**Application for a Certificate of Public Convenience and Necessity (CPCN) for
Approval of the Coastal Transmission System Transmission Integrity
Management Capabilities Project (Application)**

**Response to the British Columbia Utilities Commission (BCUC) Information
Request (IR) No. 2**

Figure 1 - CTS Capacity vs. Forecast Peak Demand (2021-2030)

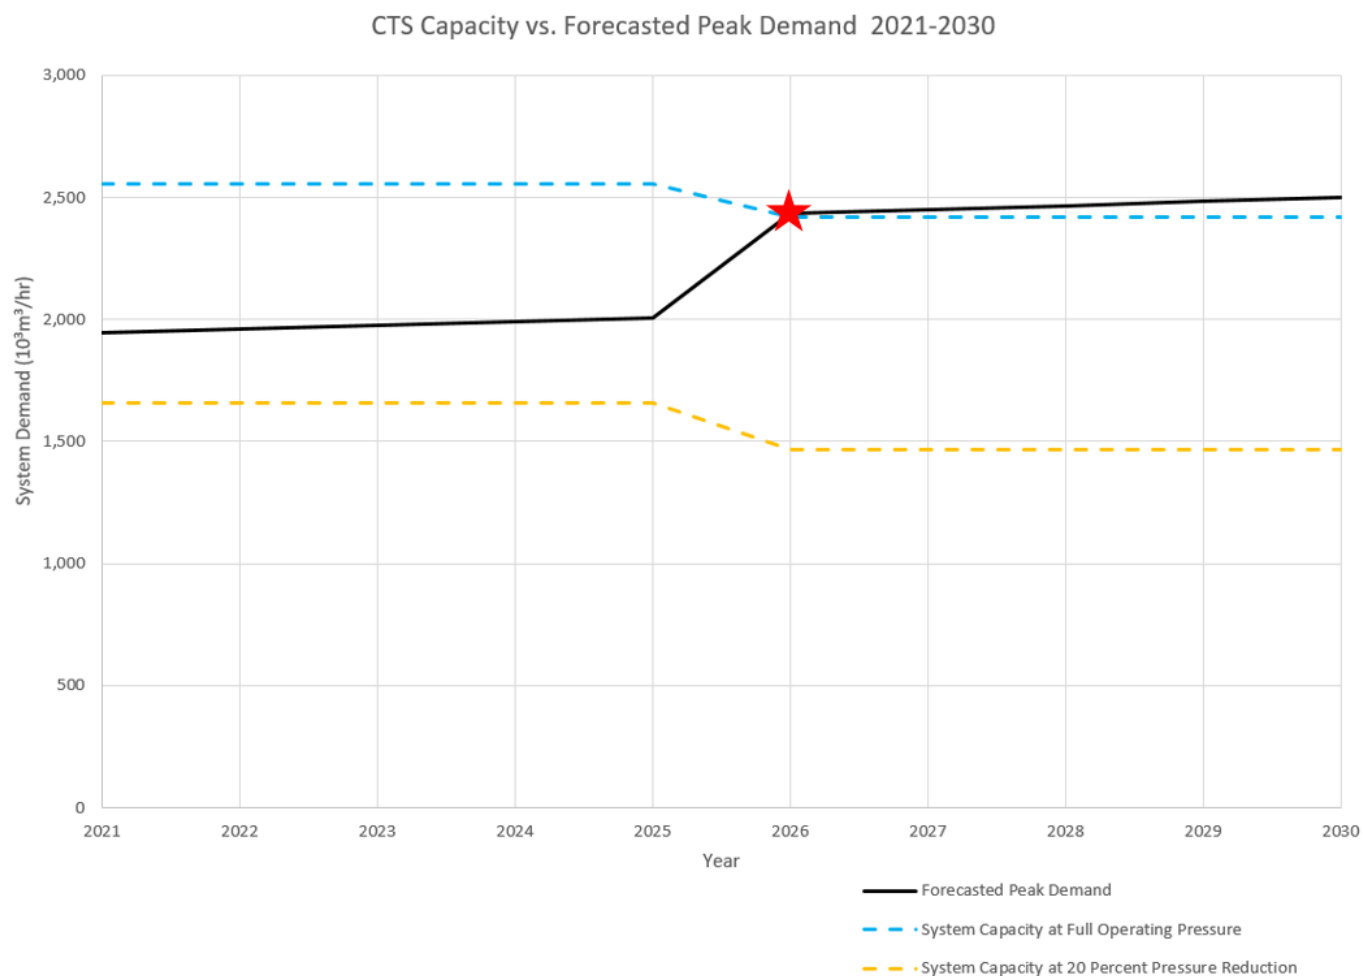
36.1 Please provide graph(s) which demonstrates that the CTS would be required to operate at full operating pressure to maintain capacity to serve customer demand, showing anticipated capacity required to serve customer demand for the period 2021 to 2030, the CTS capacity at full operating pressure and the capacity at reduced operating pressure. In the response, please provide a graph for each CTS pipeline, if available.

Figure 1 below shows the capacity of the existing CTS at both the current full operating pressure and also at a 20 percent reduction in maximum pressure. The figure also shows the forecast system peak hour demand between 2021 and 2030. As can be seen in the graph, the forecast winter peak demand exceeds the available system capacity during a pressure reduction in all years.

For illustrative purposes, Figure 1 assumes the WFLNG and Tilbury load additions occur in 2026. However, FEI does not yet have firm confirmation that the increased demand will occur in the year indicated. If both load additions proceed in the timeframe and magnitude represented in Figure 1, some additional system upgrades such as expanded compression or pipeline looping would be necessary to support the increased demand even at full operating pressure, as shown

by the demand curve crossing above the system capacity line in 2026 (indicated by the red star). Since the scope of capacity upgrades required to address the increasing demand is currently under development, Figure 1 does not show the capacity of any future upgrade(s) supporting these potential concurrent increases in industrial demand. Rather, it shows the capacity of the existing CTS infrastructure compared to the projected demand.

Figure 1 also shows that significant load additions (such as the proposed Tilbury expansion and the WFLNG facility) will actually reduce the available system capacity reported. This is because the demand of these facilities are concentrated at specific locations on the system and not distributed across the system in the same way that increased residential and commercial customer loads would attach to the system. As a result, these large point-load additions can cause pressures in the system to reach minimum values sooner (i.e. system capacity limits are reached sooner) because they are located close to the furthest downstream points of the system. FEI further discusses the method for determining CTS capacity in the response to BCUC IR2 36.1.1.

Figure 2 - Segments of the Cape Horn to Burrard 508 Transmission Pipeline

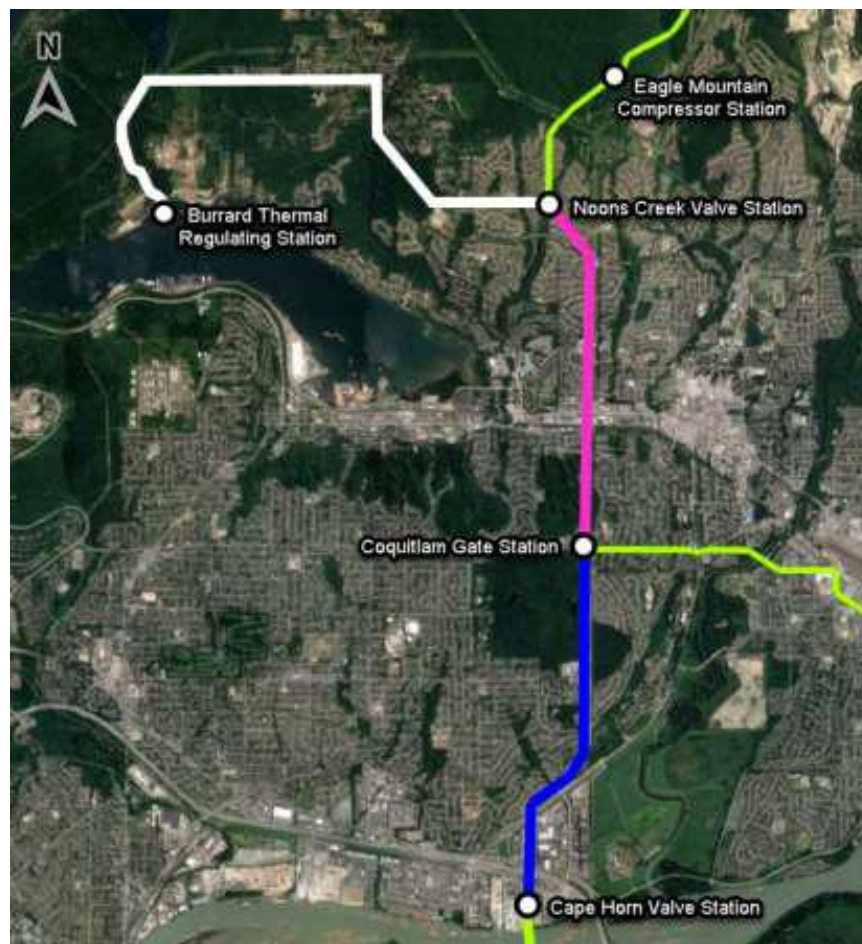
42.1 Please provide the operating characteristics listed in Table 1 based on the anticipated operation following the completion of the expansion at Eagle Mountain compressor facility required to serve the Woodfibre LNG Project.

averages with some allowance for growth in demand, FEI is unable to estimate the expected impacts on average values for facilities that are not in operation and are still in various stages of design. However, FEI provides Table 1 below showing the ranges of pressures and flows that could be anticipated should the expansion proceed at the Eagle Mountain compressor facility to serve the Woodfibre LNG Project. Figure 1 below is also reproduced from BCUC IR1 11.4.1 for reference.
